VIRM: IN-SERVICE CERTIFICATION AMENDMENT 1 JUNE 2019

List of changes and preview pages (WoF only)

MAY 2019

Figure 5-1-4. Windscreen critical vision area (CVA)

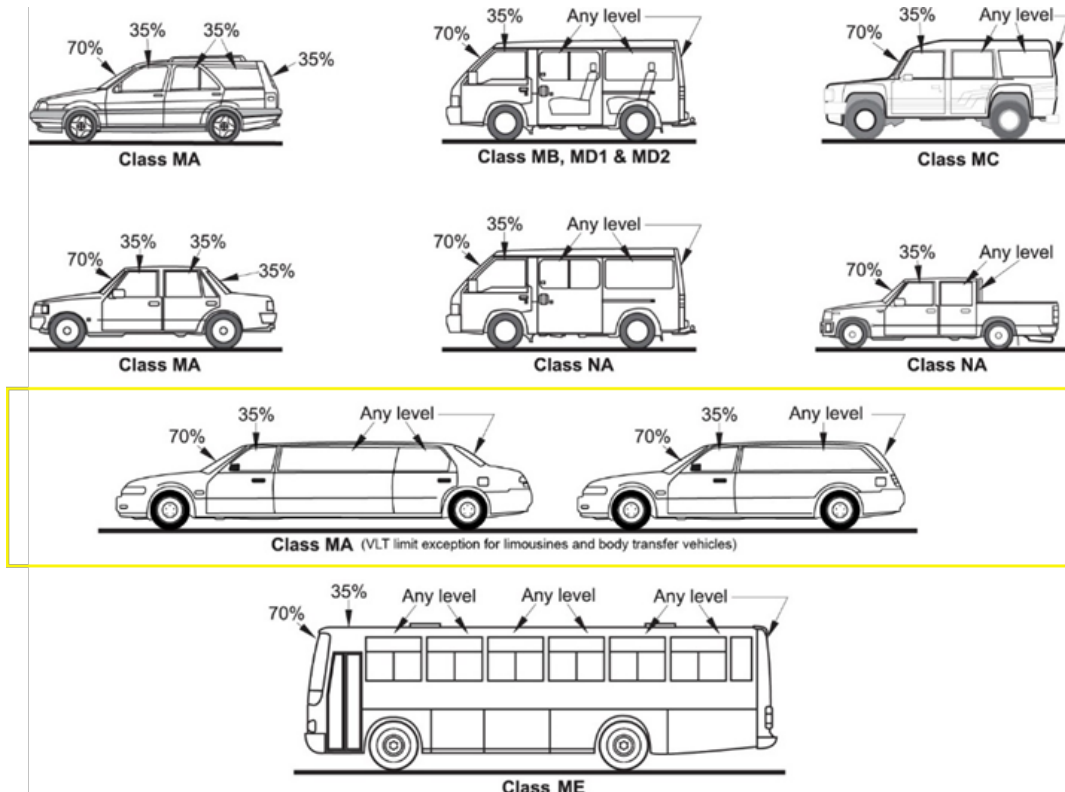
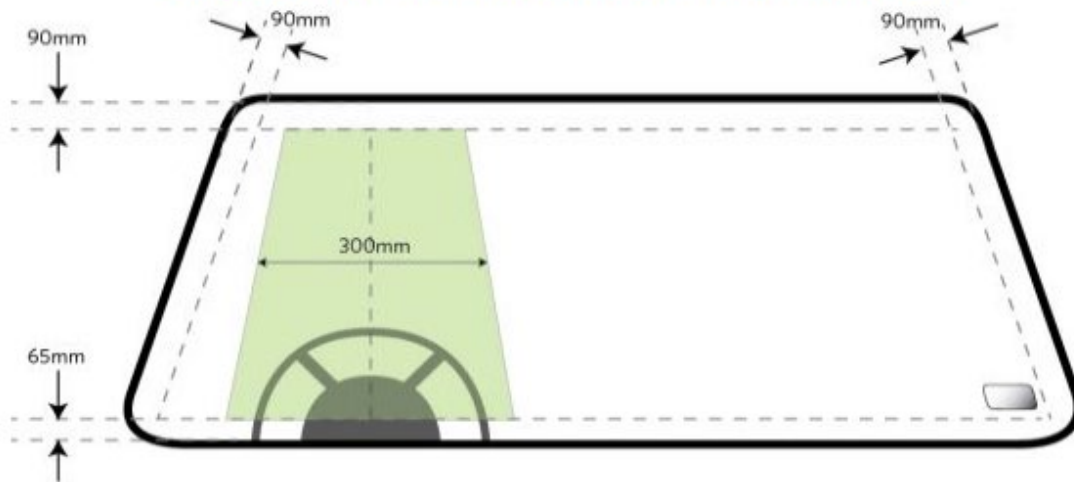
SECTION	CHANGE DESCRIPTION
General vehicles	
4-1 Headlamps	<ul style="list-style-type: none"> • Rfr 15(h) updated to allow for vehicles without a headlamp warning device to be passed if one is not fitted (fitted but not working is still a fail item)
5-1 Glazing	<ul style="list-style-type: none"> • Limousine and body recovery vehicles (hearse) added to figure 5-1-6 Minimum VLT limits for modified glazing (tinted overlays) for different vehicle classes • Critical vision area diagram updated to align with AS/NZS 2080-2006
General trailers	
3-1 Structure	<ul style="list-style-type: none"> • Note and image added to assist vehicle inspectors with spotting cracking failure at the point(s) where the drawbar attaches to the body of the trailer in light trailers • Repaired Trailpro trailers can be identified by the 'R' after the serial number on the plate • Image of a repaired Trailpro trailer

To be measured from the inside of the vehicle from the point where the glass is visible (ie after any seals)

15 Identifying compliant hitches and brake systems

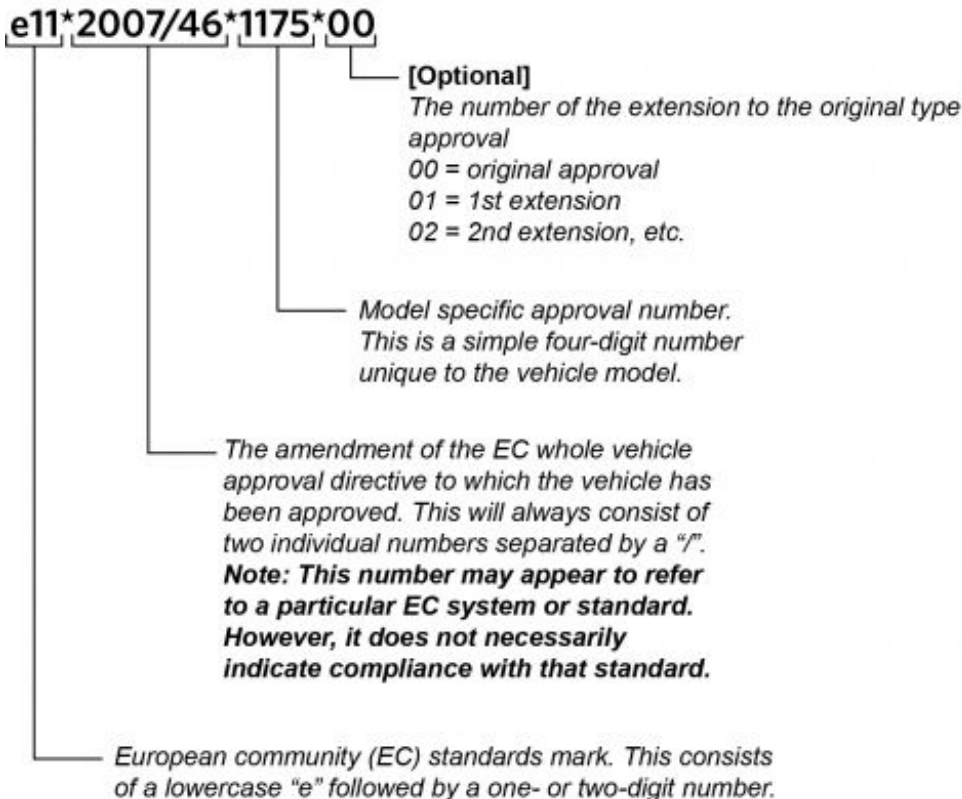
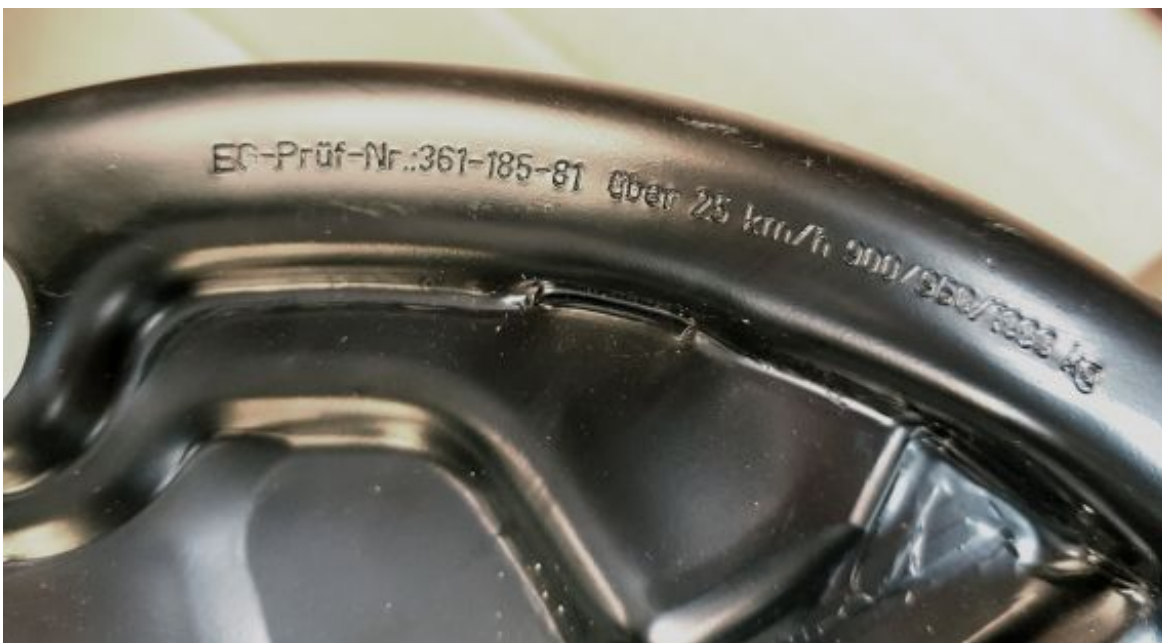
beyond the body or load of the vehicle, whichever it is attached to (frangible means breakable or readily deformable)
General trailers	
2-2 Dimensions	<ul style="list-style-type: none"> • See general vehicles
5-1 Brakes	<ul style="list-style-type: none"> • Proposal 6: The objective of the amendment Rule is to allow for trailers weighing between 2,500 kg and 3,500 kg to have indirect service brakes or direct service brakes
Forklifts	
2-2 Dimensions	<ul style="list-style-type: none"> • See general vehicles
Tractors	
2-2 Dimensions	<ul style="list-style-type: none"> • See general vehicles
Unclassified vehicles	
2-2 Dimensions	<ul style="list-style-type: none"> • See general vehicles
Technical bulletins (general)	
15 Identifying compliant hitches and brake systems	<ul style="list-style-type: none"> • New technical bulletin to assist vehicle inspectors identify brakes compliant with UN/ECE regulation 13

- A compliant hitch will be fitted with a plate like the one above that indicates it is compliant to Reg. 55 as per the red highlighted section in the image.

- A compliant brake system will require 4 brakes acting across 2 axles (one per wheel). The back of each brake drum will have a test number marking like that shown above.
